UNITED STATES
NUCLEAR REGULATORY COMMISSION
WASHINGTON, D. C. 20555

SUBJECT: OPERABILITY OF THE ALTERNATE MINIMUM FLOW PATHS FOR THE HIGH-HEAD
SAFETY INJECTION PUMPS (TAC NO. M84935)

NRC INFORMATION NOTICE 92-61, SUPPLEMENT 1: LOSS OF HIGH HEAD
SAFETY INJECTION

FIGURE 1
EXISTING SHEARON HARRIS HIGH HEAD INJECTION SYSTEM

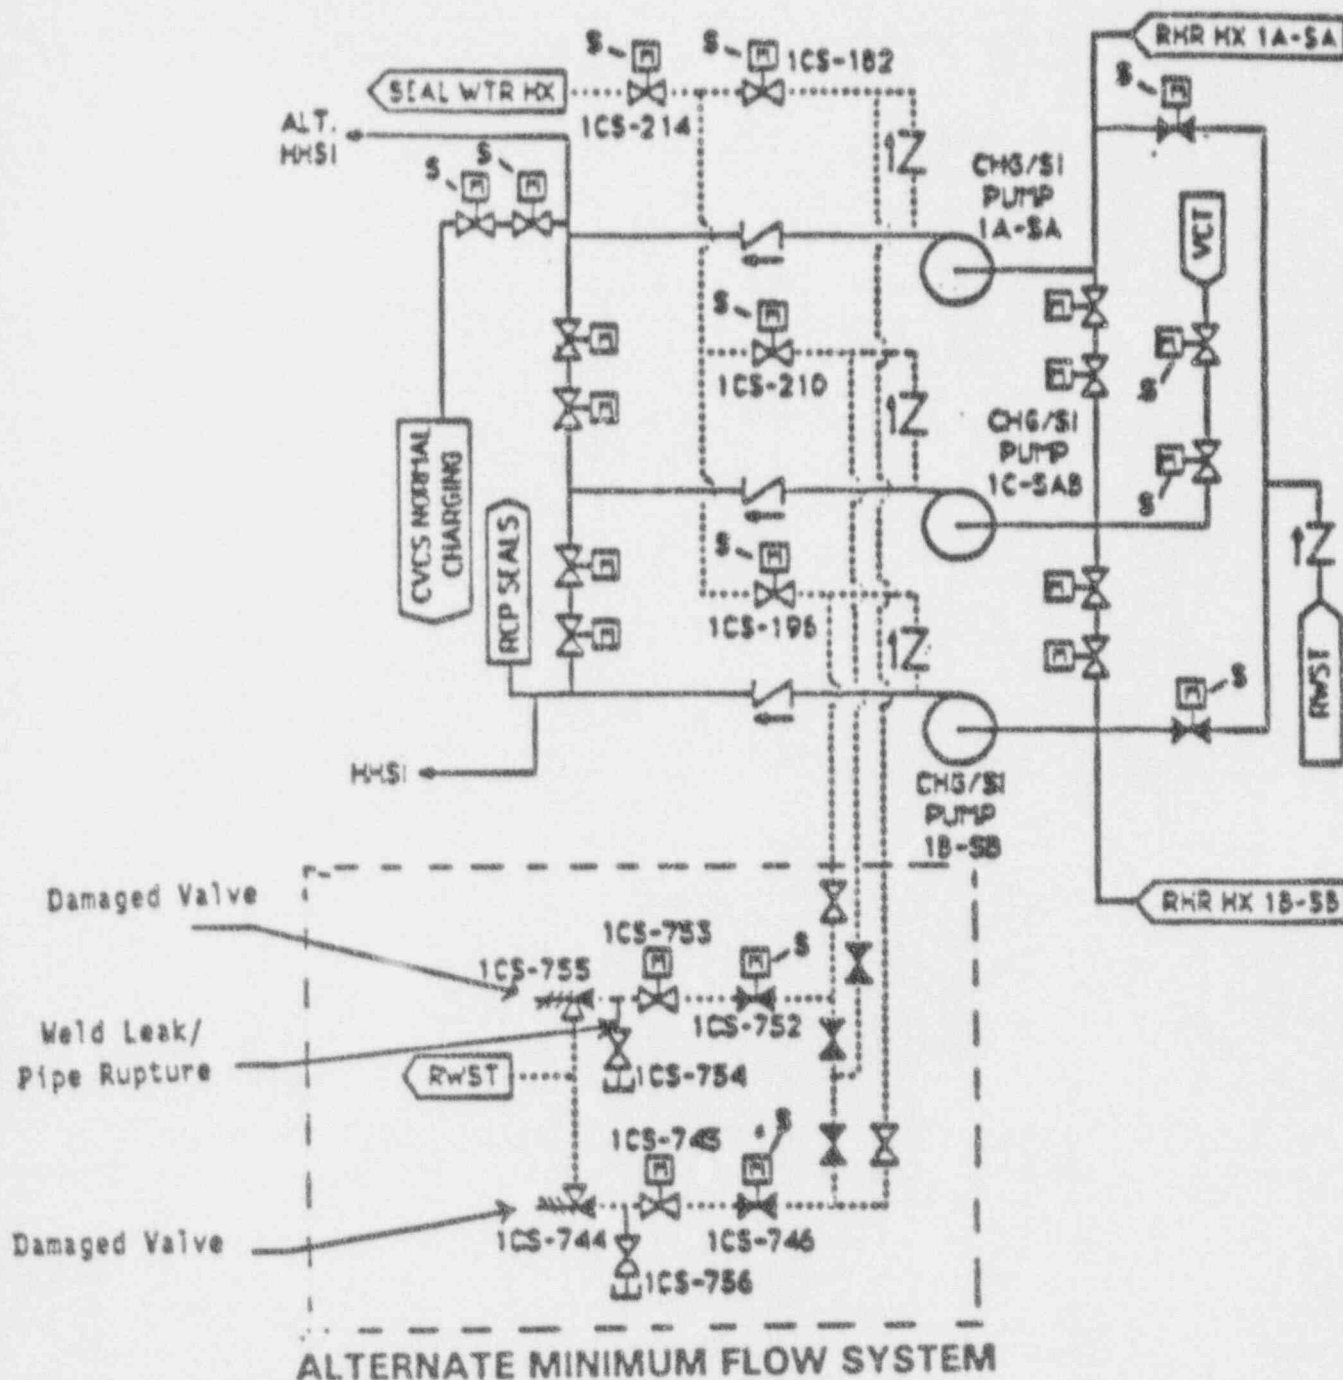
On April 3, 1991, Carolina Power & Light Company (the licensee) determined that the HHSI system for the Shearon Harris Nuclear Power Plant had been in a degraded condition during the previous operating cycle. The degraded condition resulted from relief valve and drain line failures in the AMF system for the charging/safety injection pumps (CSIPs) which would have diverted a significant amount of safety injection (SI) flow away from the reactor coolant system (RCS). Additional description of the existing AMF system and additional discussion regarding the specifics of this event are contained in Information Notice 92-61, "Loss of High Head Safety Injection," dated August 20, 1992, and in NRC Special Inspection Report 50-400/92-201, dated September 1, 1992. In addition, Figure 1 provides a schematic of the existing HHSI system at Shearon Harris.

On September 17, 1992, the licensee tested the HHSI AMF system. When the 1CS-746 motor-operated isolation valve was opened to test train "A" of the HHSI AMF system (1CS-746 will stroke fully open in approximately 7 seconds), relief valve 1CS-744 chattered slightly for several seconds and then

successfully opened. When the ICS-752 motor-operated isolation valve was opened (also requiring approximately 7 seconds) to test train "B" of the HHSI AMF system, relief valve ICS-755 chattered significantly, the valve bellows failed, and the test was halted. Additional discussion regarding these tests is contained in NRC Inspection Report 50-400/92-17, dated October 1, 1992.

The licensee has indicated that the chattering of the ICS-755 relief valve is believed to have been caused by hydraulic effects associated with opening the ICS-752 motor-operated isolation valve. The NRC staff believes that the fluid frictional and dynamic pressure loss characteristics of the long inlet piping upstream of ICS-752 may have also contributed to the chattering. The licensee indicated that the testing, disassembly, and examination of the ICS-755 relief valve identified that the valve lift setpoint (2300 psi) had not changed, and that the bellows failure was caused by cyclic fatigue of an inside weld. Static testing to verify the valve lift setpoint had been routinely performed, during the plant lifetime, whereas testing to simulate flow through the valve to assure proper operation and reseating apparently never was performed.

The Crosby relief valve technical manual states that chattering can affect the life, operation, and performance of a relief valve. The manual recommends that relief valves not have restricted inlets because restricted inlets can cause valve chatter. The opening and closing of the motor-operated isolation valve in the existing HHSI AMF design at Shearon Harris restricts the inlet to the relief valve. In addition, relief valves are generally designed to provide system overpressure protection and are not designed for continuous fluid throttling purposes.

FIGURE 2
MODIFIED SHEARON HARRIS HIGH HEAD INJECTION SYSTEM

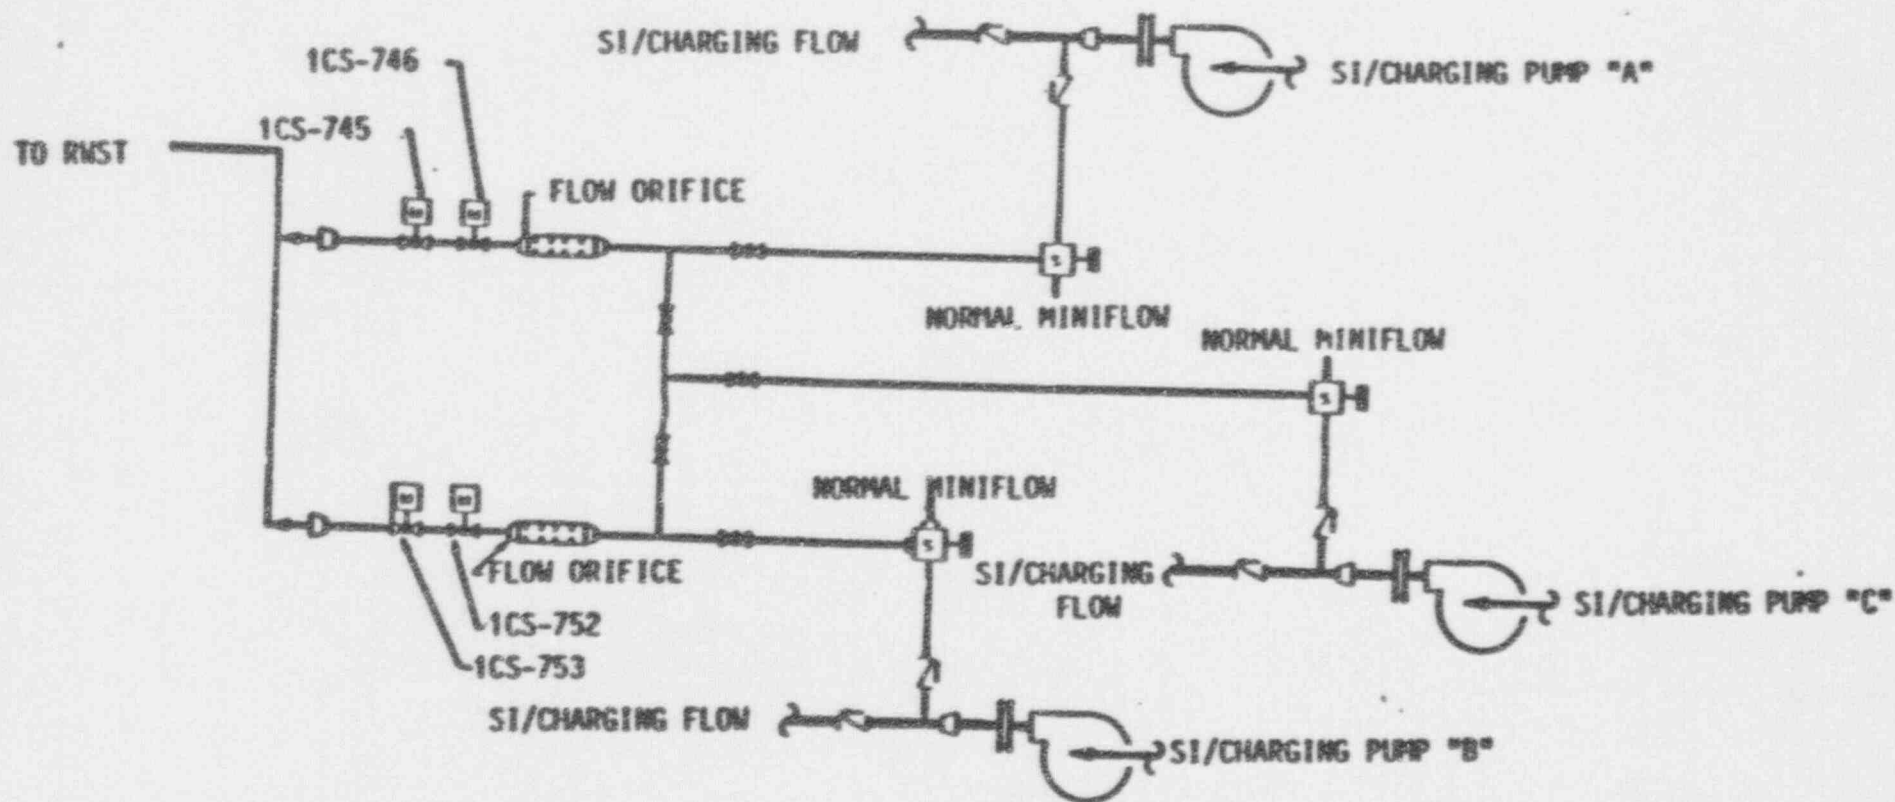
The licensee also indicated that modifications will be made to the HHSI AMF system before restarting the plant from the current refueling outage. Figure 2 provides a schematic of the proposed modifications to the HHSI AMF system at Shearon Harris. The licensee intends to install flow restricting orifices upstream of the motor-operated isolation valves and to remove the relief valves. The motor-operated isolation valve actuation logic will also be modified so that the isolation valves will open when a safety injection signal is present coincident with RCS pressure above approximately 2300 psi.
